**MODEL TITANIUM2**  
**(Machine Code: C261)**

**SERVICE MANUAL**  
**(Insert version)**

The Titanium2 will be released in 2006 as the successor to the Titanium. A new model code will be assigned to the Titanium 2 (C261), as there is full compliance with the RoHS and WEEE directives.

#### *Accessory check*

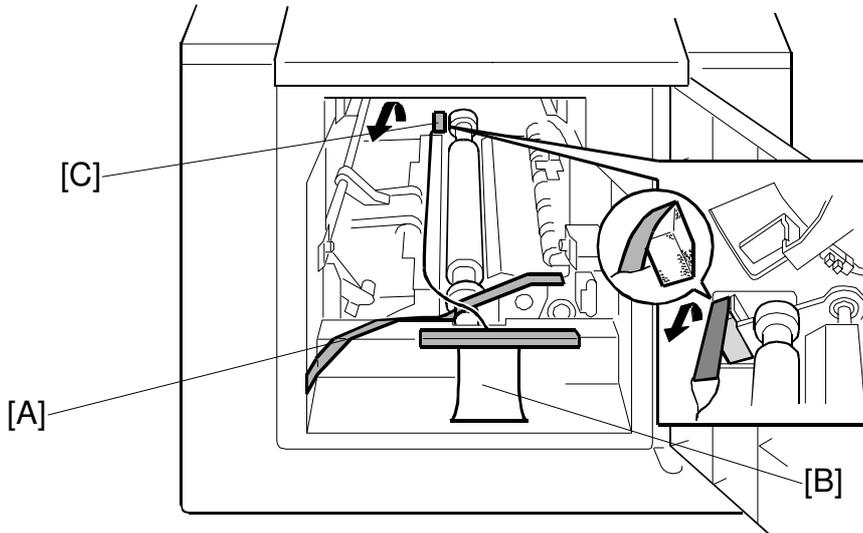
**Change:** The accessories are changed (C261 only).

C2611901.WMF

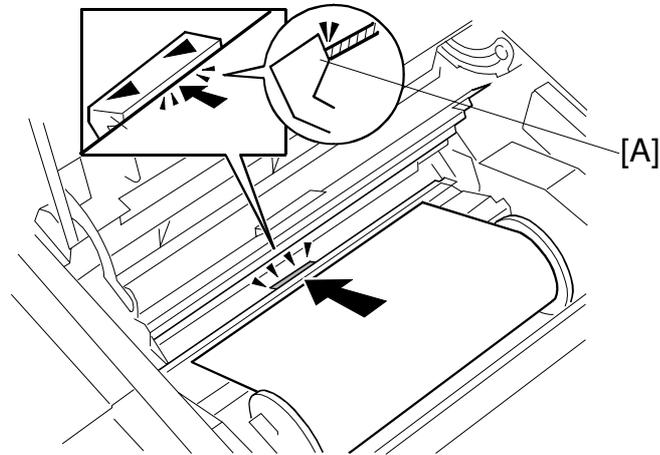
C252/C261: Remove the front tape, the tag and the rear tape after step 2. Then do step 3.

Remove the front tape [A], the tag [B], and the rear tape [C].

#### 3.9.2 CLOTH SCREEN

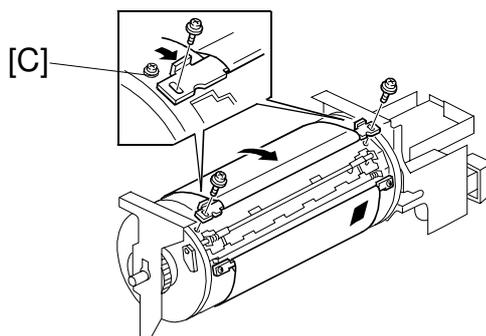
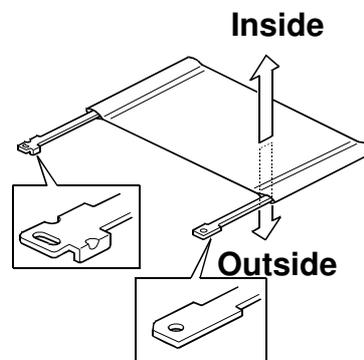
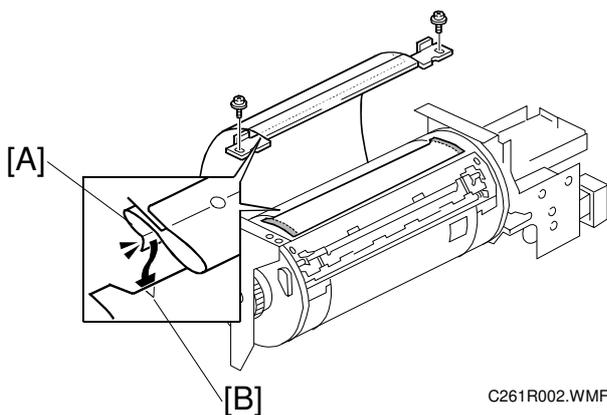
C252/C261: The mylar seal of the metal screen was changed only at the sides.

C252/C261: The cloth screen was changed to an all-in-one design (belt cloth).

- Do not scratch the cloth screen or metal screen.
- Properly insert the edge of the belt crossing [A] on the cloth screen under the mylar [B] on the metal screen, as shown above. Otherwise, ink will leak from the trailing edge of the master on the drum during a long printing run.

- Make sure that the correct side of the screen is facing up. In addition, make sure that the stays for securing the cloth screen are positioned correctly. (Refer to the upper right illustration.)
  - When replacing the cloth screen, spread the screen around the metal screen while strongly pulling the stay [C]. Adjust the stay so that it is parallel to the master clamber, then tighten the screws.
- Make sure that the cloth screen is not wrinkled while spreading it around the drum.

### 3.9.3 CLAMPER / METAL SCREEN

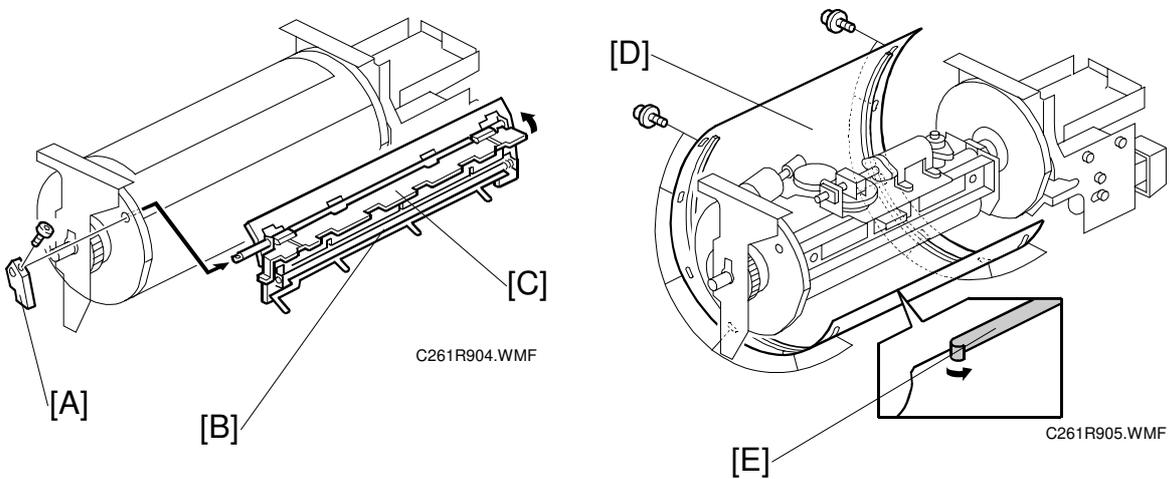
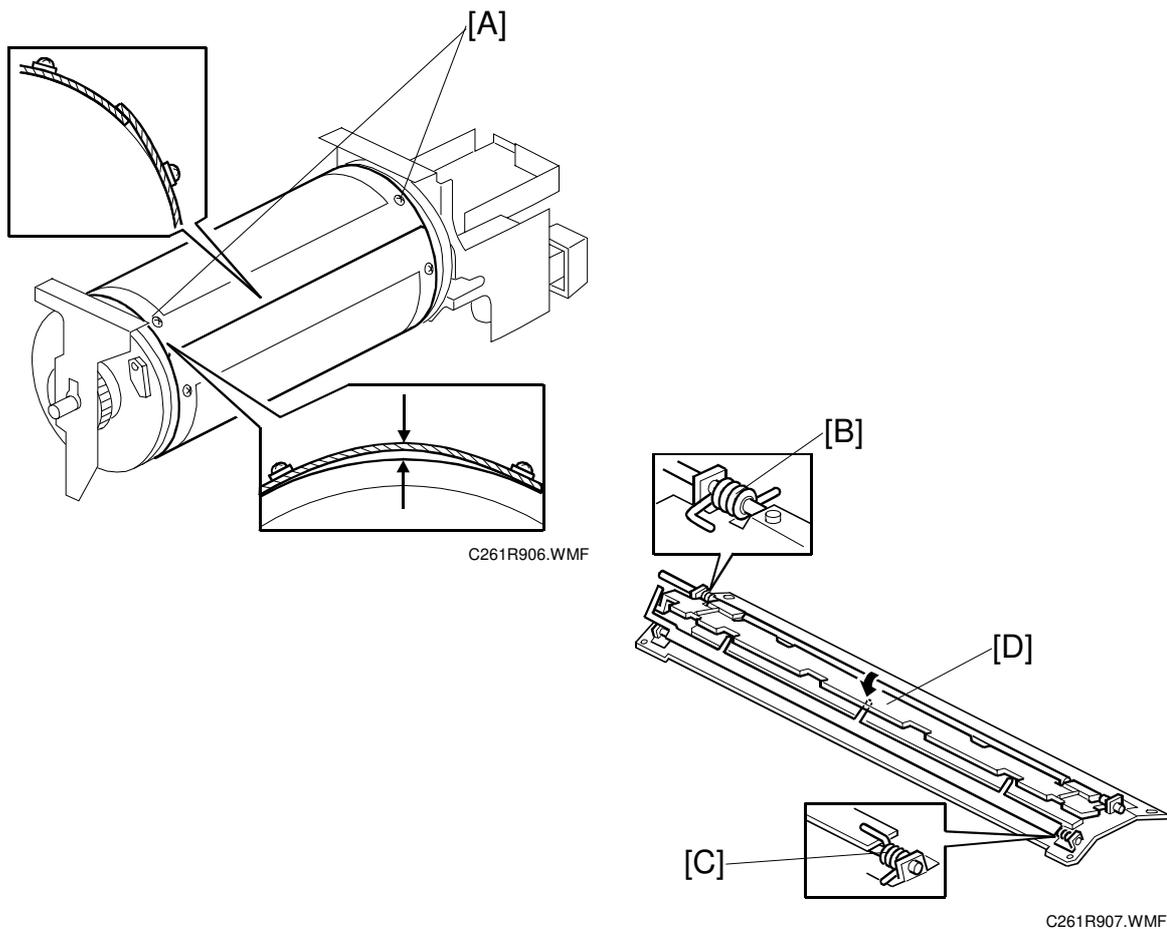
C252/C261: Notes about the method for overlapping the metal screen are added.

- Make sure that the correct end of the metal screen is overlapping. (The right side overlaps, as viewed from the non-operation side, as shown above.)
- Secure the metal screen with filament tape.

- When installing the metal screen, secure the trailing edge first with the 2 screws. Then, tighten the other screws while removing the slack from the screen. Make sure that the gap between the drum flanges and the screen is 0.3 mm or less, as shown above. (The two holes [A] on the trailing side are round holes and the other holes are long holes, to allow for the removal of the slack.)

### 3.9.4 INK PUMP ADJUSTMENT

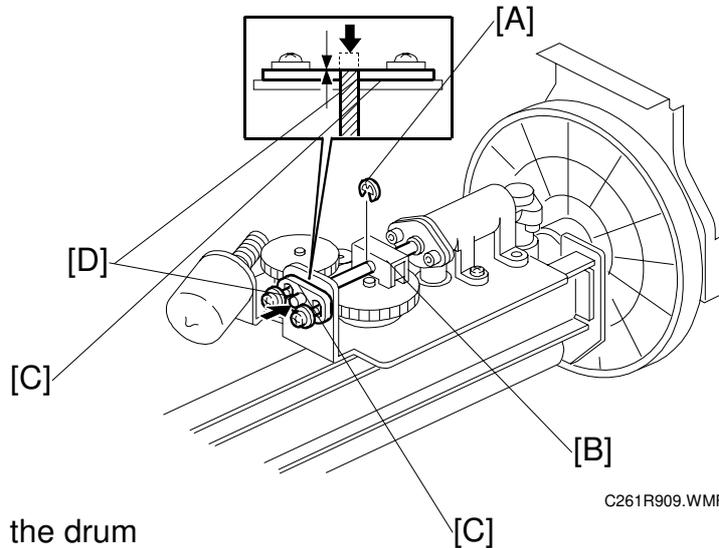
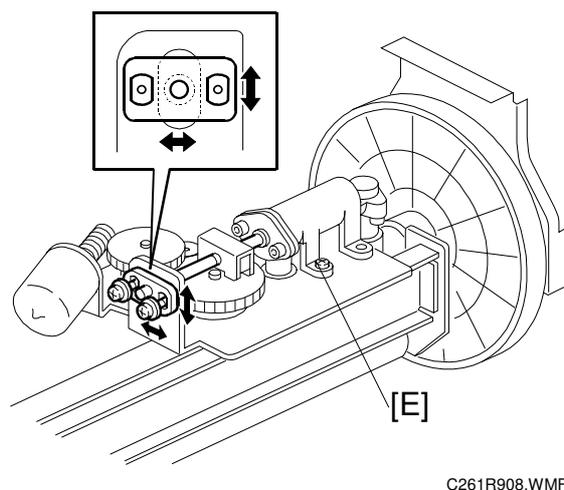
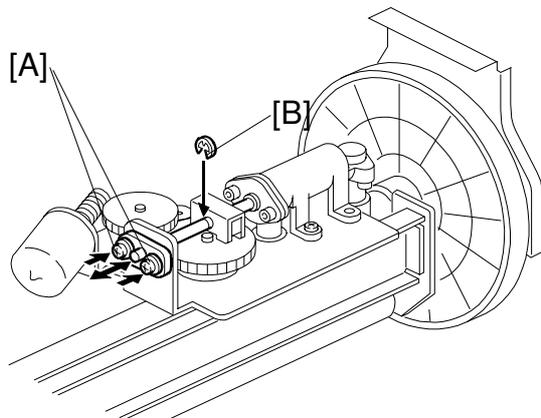
C252/C261: To improve the accuracy of the adjustment, the plunger adjustment was changed.

**Purpose:** To ensure the smooth operation of the ink pump plunger by properly positioning its holder.

1. Remove the E-ring [A] to free the plunger from the pump drive slider [B].
2. Loosen the two screws securing the holder [C]. (Do not remove the holder.)
3. Push the plunger [D] until it reaches the bottom.

**NOTE:** The end of the plunger [D] should not project outside from the holder [C].

4. Check that the piston motion is smooth.
5. If the motion is stiff, loosen the pump screws [E] and adjust the pump position.

6. After tightening, repeat step 4 and step 5.

7. Re-tighten the two screws [A].
8. Check that the piston motion is smooth.
9. Reinstall the E-ring [B].

### 3.10.3 VACUUM FAN MOTOR POSITION

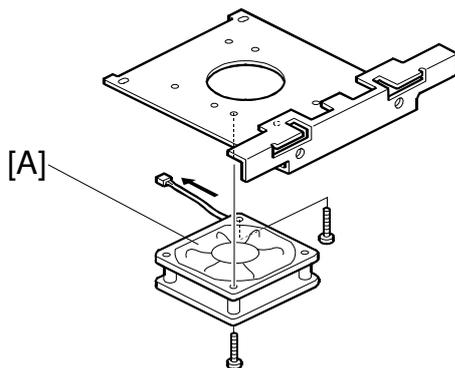
**Change:** The vacuum fan motor [A] position is the same for all models.

**Reason:** The type of the fan motor was changed from a 'sirocco vane' type to an axial fan motor, to improve the performance of paper delivery.

#### 6.4.1 IMAGE PROCESSING FLOW

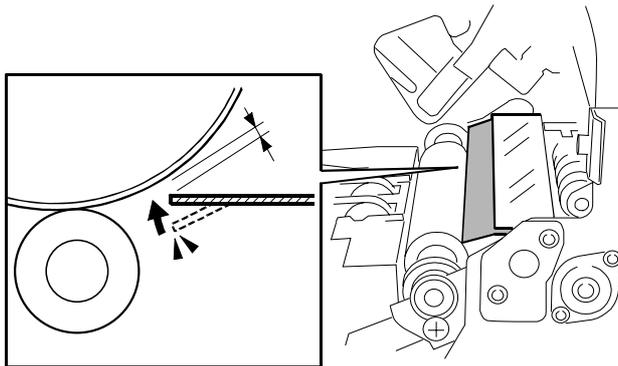
C261 only: The Text/Photo mode was added. Text/Photo mode: Error diffusion (Text is reproduced better than with Photo mode.)

### 6.6.6 DETECTION OF MASTER ON THE DRUM

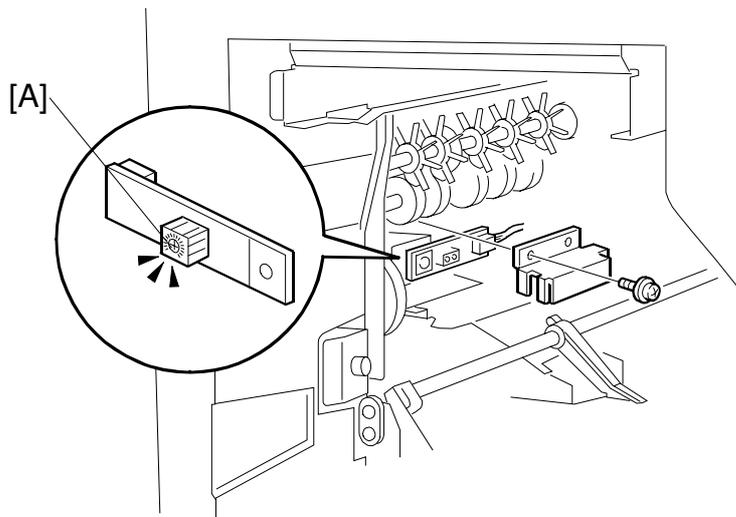
C261 only: A VR [A] was added for this sensor. This VR is for factory use only. Do not adjust it in the field.

### 6.6.7 METAL SCREEN

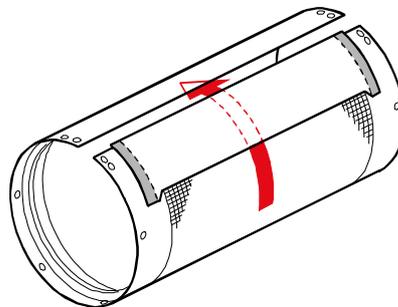
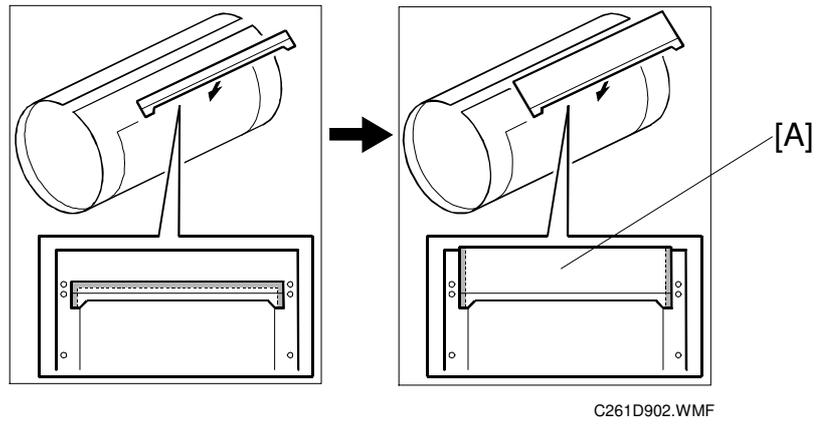
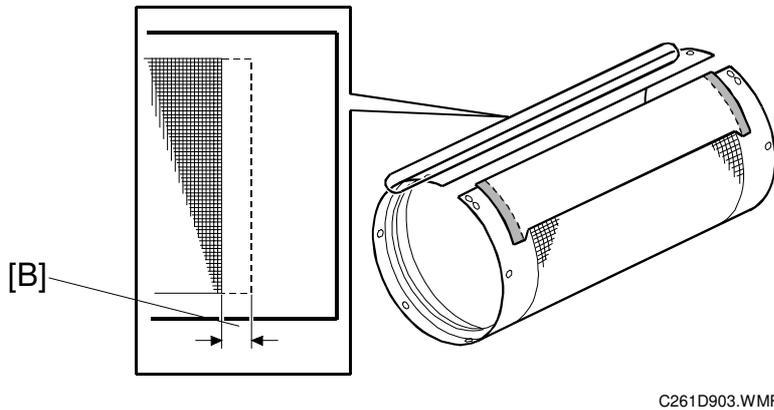
- C252/C261: The metal screen was changed to improve image production on the paper.

The adhesive parts [A] are only at the sides of the mylar seal for the metal screen. (They were removed from the trailing edge.) This prevents ink leakage from the trailing edge.

The leading edge of the mesh on the metal screen is reduced by 2.5 mm [B]. This prevents small dots at the leading edge of the paper.

### 6.8.1 PAPER DELIVERY UNIT DRIVE MECHANISM

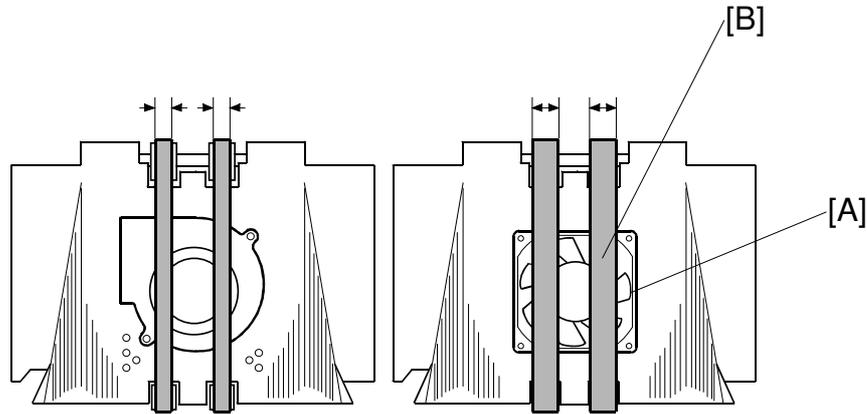
- C261 only: The paper delivery performance was improved by changes to the vacuum fan motor and the transport belt.

The type of fan was changed from a sirocco vane motor to an axial fan motor [A].

The transport belt [B] is wider.
